MACTHOMPSON SITE PLAN

SP# 12-21

STAFF REPORT

PLAN UNDER REVIEW: Macthompson Site Plan, 48 Lowell Road, Tax Map 190 Lot 191, Hudson, New Hampshire; prepared by Benchmark LLC, 1F Commons Drive, Suite 35, Londonderry, New Hampshire 03053; prepared for owner Macthompson Realty, Inc., 3 Marmon Drive, Nashua, New Hampshire 03060; consisting of 10 sheets with General Notes 1-27 on Sheet 3; dated August 3, 2021.

SCALE: 1"=30' SHEET 5 OF 10 AUGUST 3, 2021

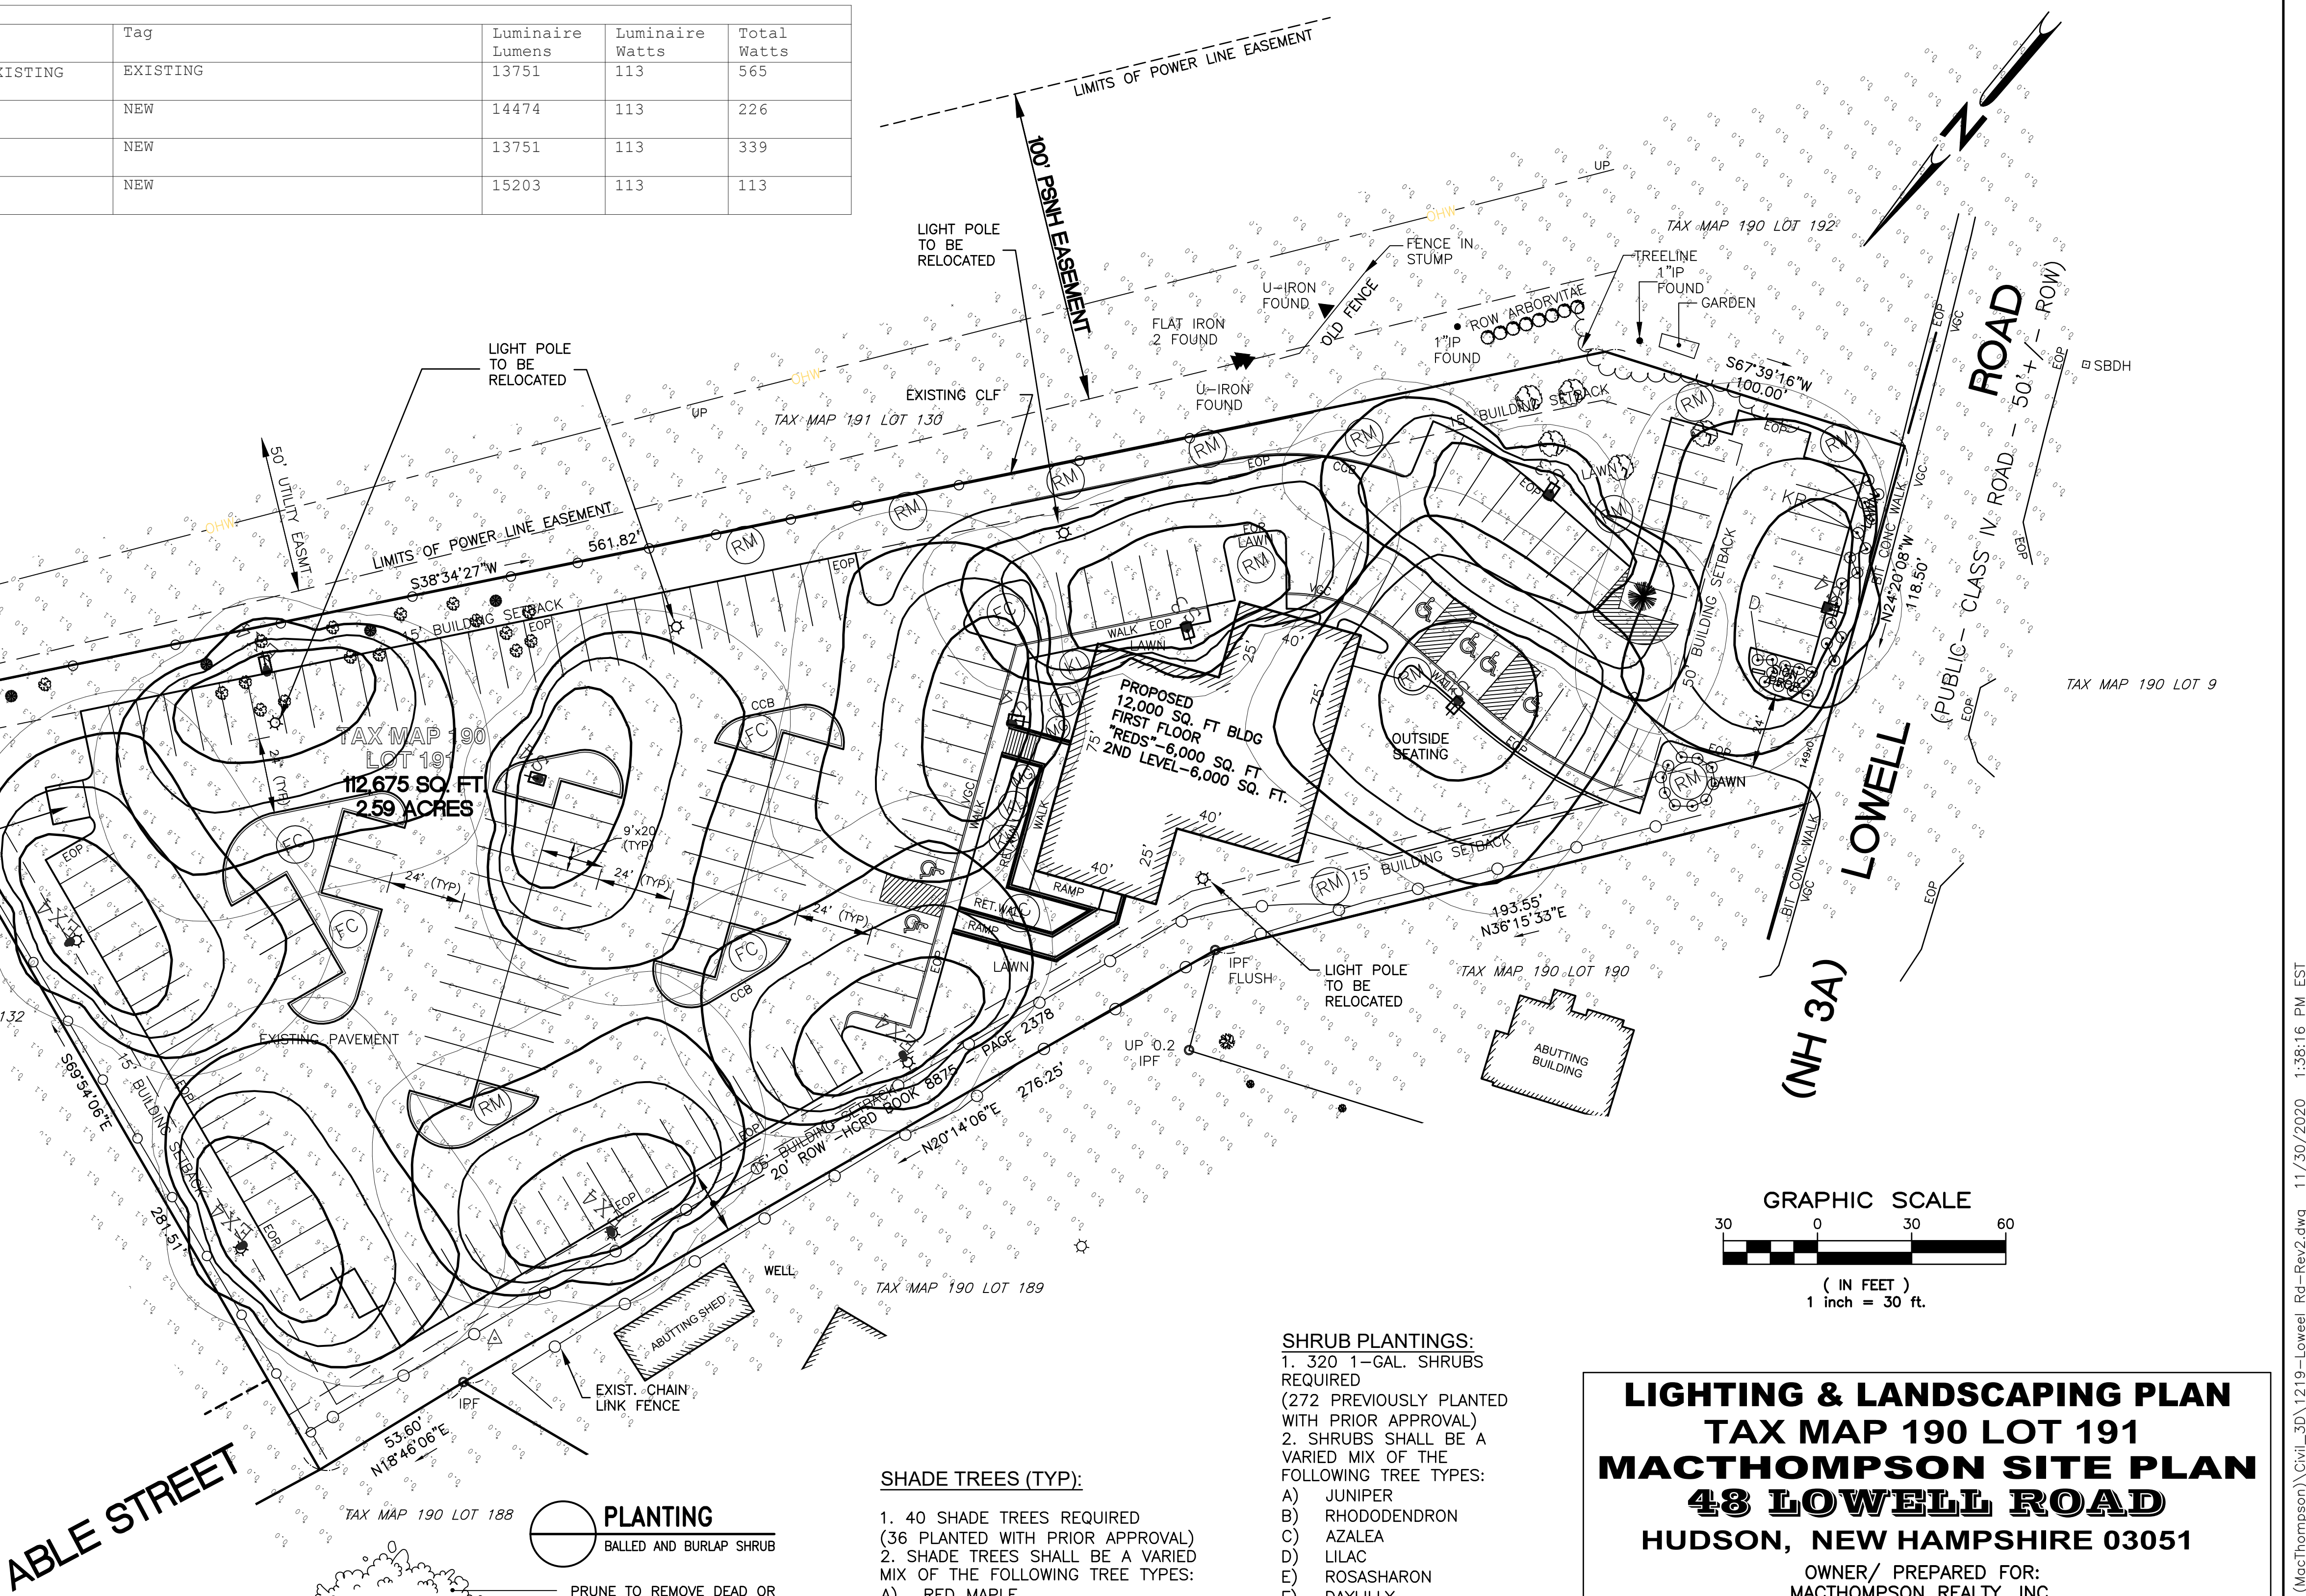
The Applicant states that the minimum required landscape plantings will be provided however it is unclear on the lighting & landscape plan (Sheet 5). Furthermore, staff request the Applicant provide a clear landscape plan separate from the lighting plan.

- c. **Parking Lot Landscaping Requirements [§ 275-8.C(7)]:** Staff find the submitted landscaping and lighting plan with overlapping details difficult to read. Staff suggest the Applicant separate the plans as two separate sheets.

As note in Staff Comment #1, the Applicant is requesting a waiver for the interior landscaping requirement. The submitted plan provides only 6% out of the 10% required interior landscaping.

SCALE: AS NOTED SHEET 7 OF 10 AUGUST 3, 2021

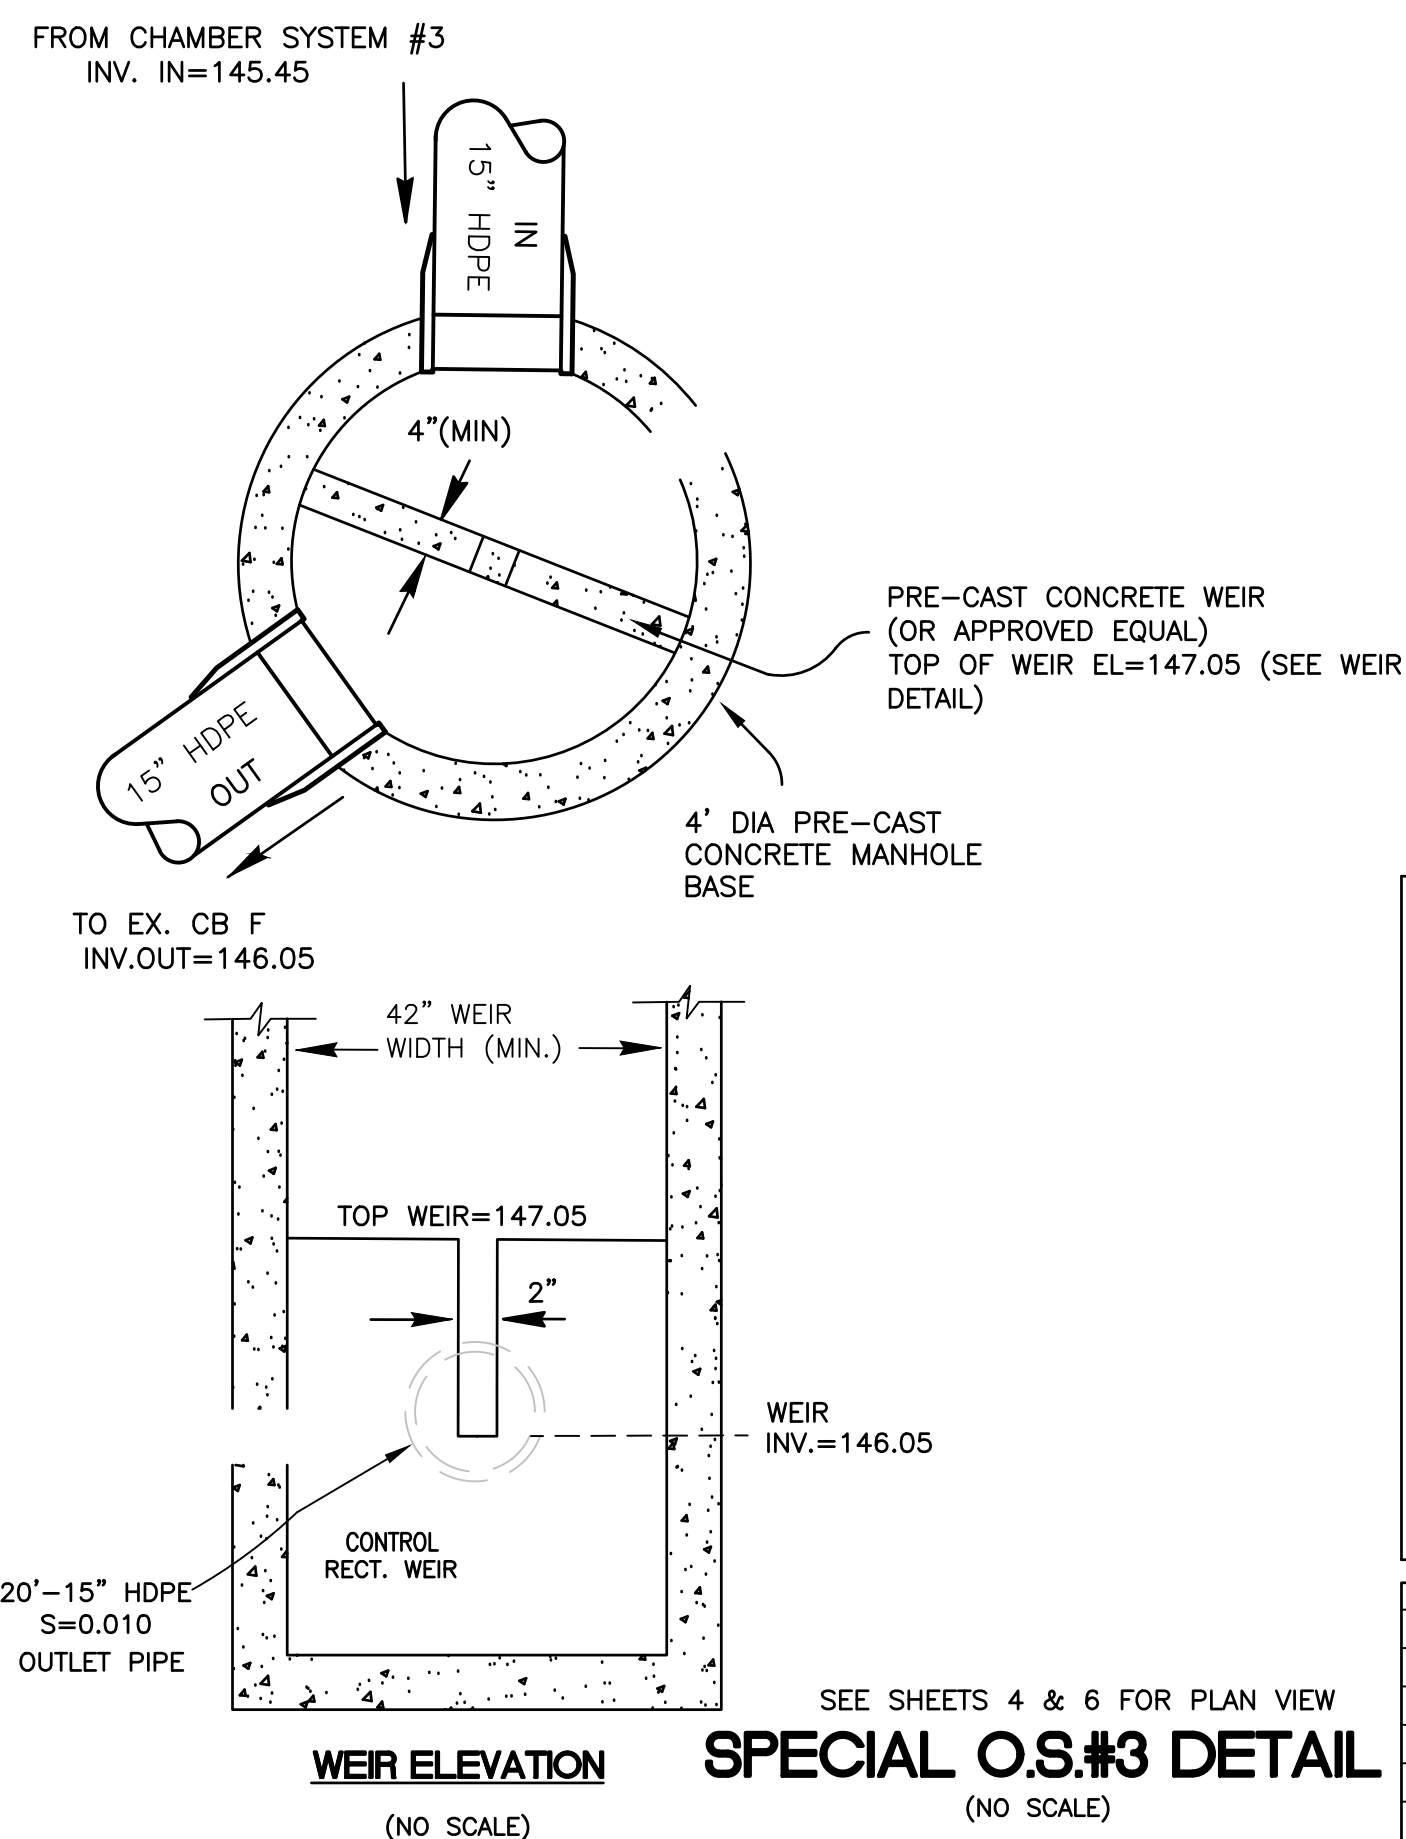
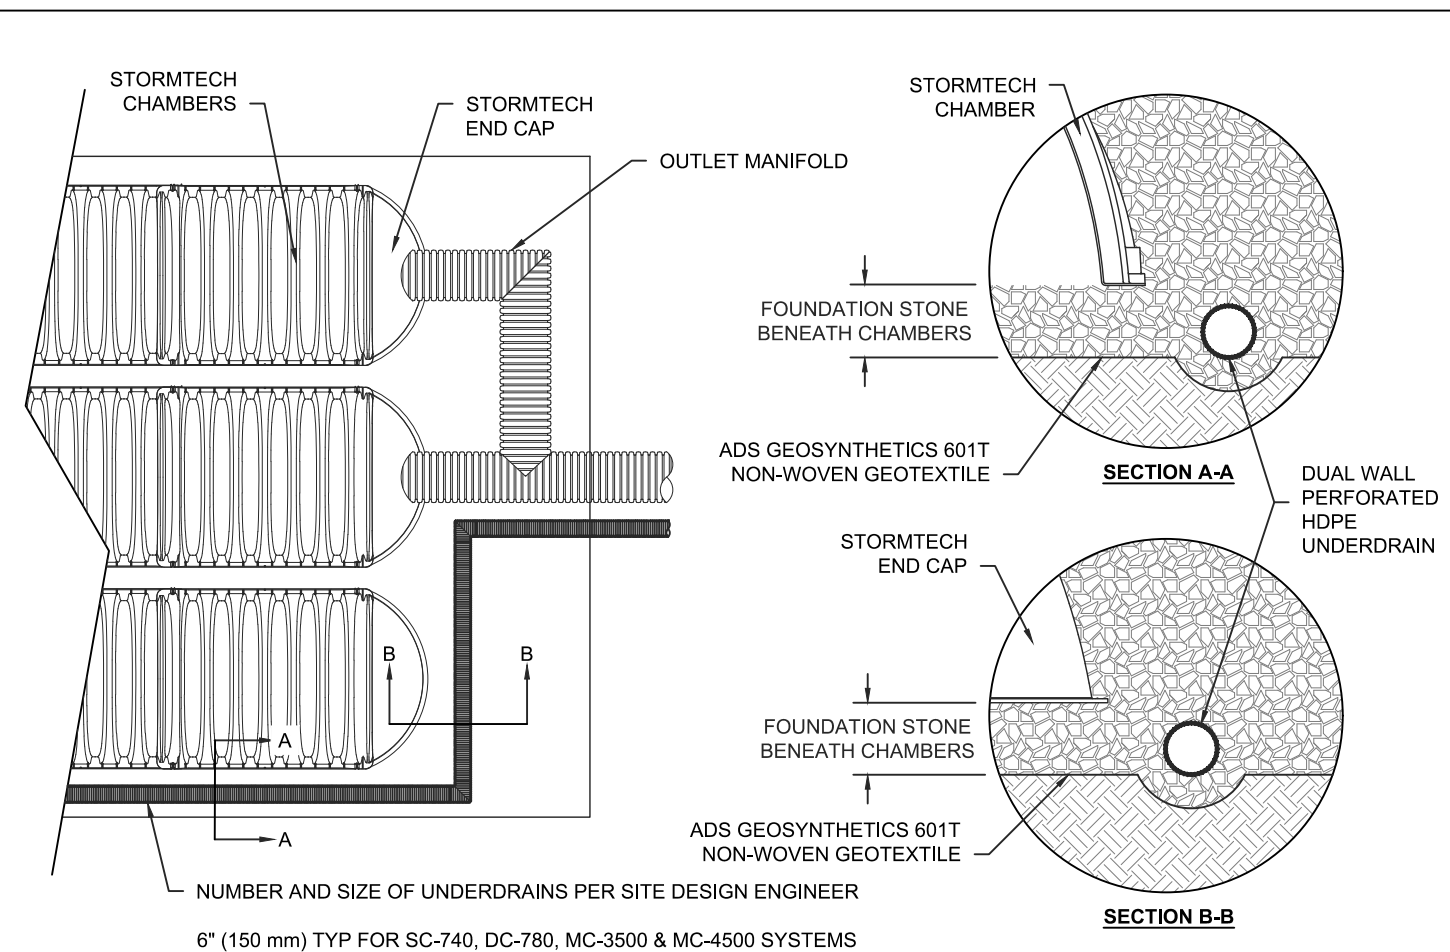
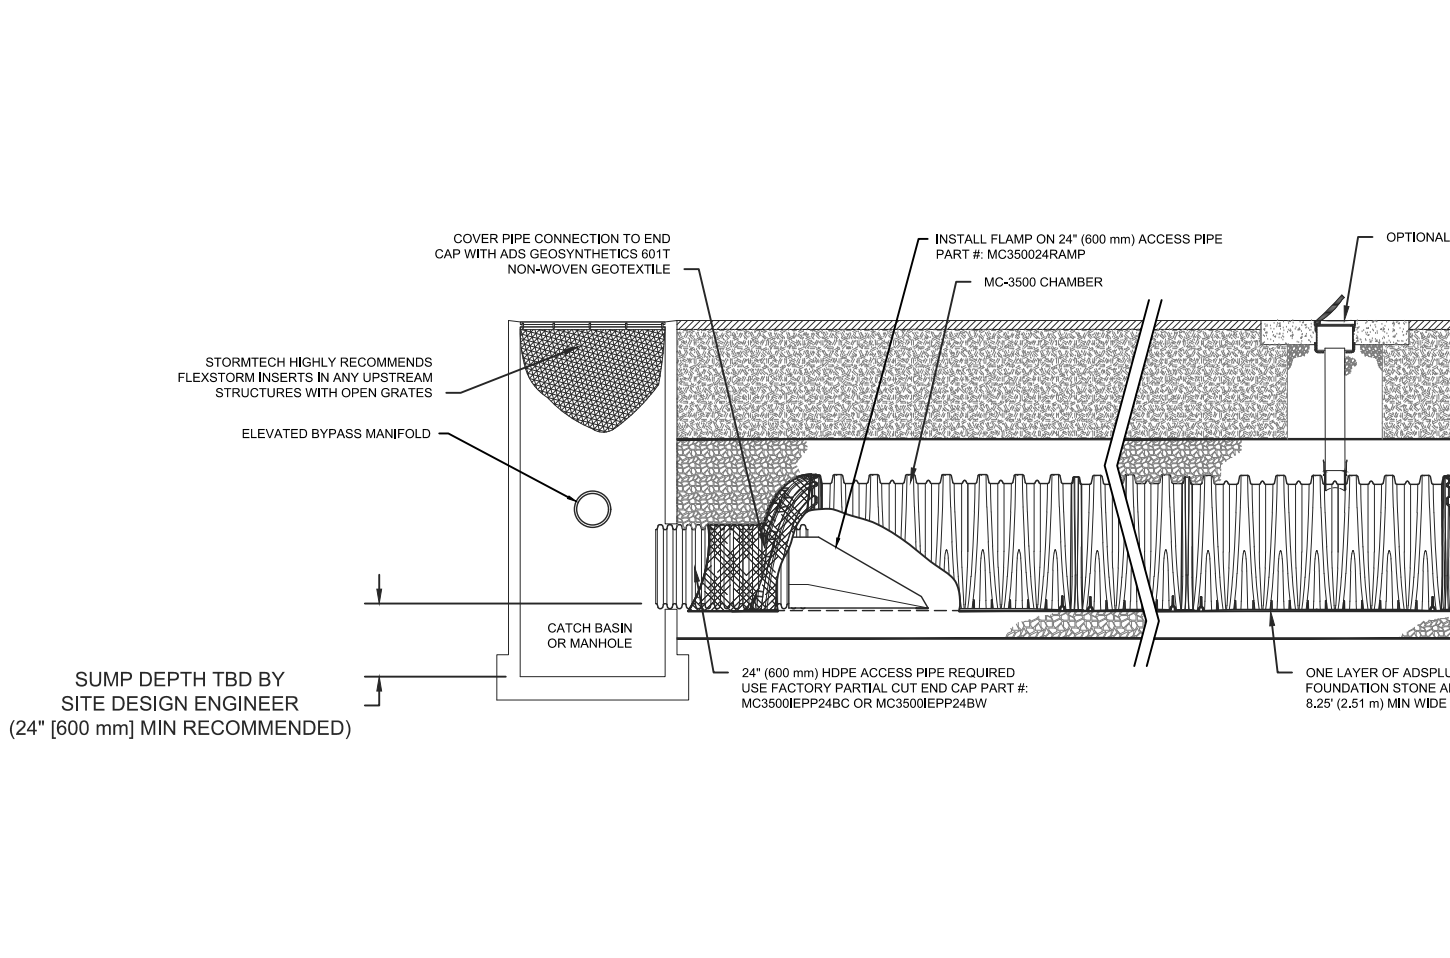
- q. ETGTD 930.3. The applicant should provide additional information on the drainage manhole detail provided upon Detail Plan Sheet #7. We note all DMH's on the plans are listed as "existing" as well as no sump is provided for the DMH.

- r. ETGTD 930.3. The applicant should coordinate the weir width of the Special OS#3 Detail on Plan Sheet #7 with the HydroCAD (2.0" vs 2.5").
- s. ETGTD 930.4. We note that the majority of the stormwater design utilizes pipe slopes of less than the required 2.0%. The applicant should review these pipe slopes and provide calculations showing that the drain line velocities are self-cleaning.
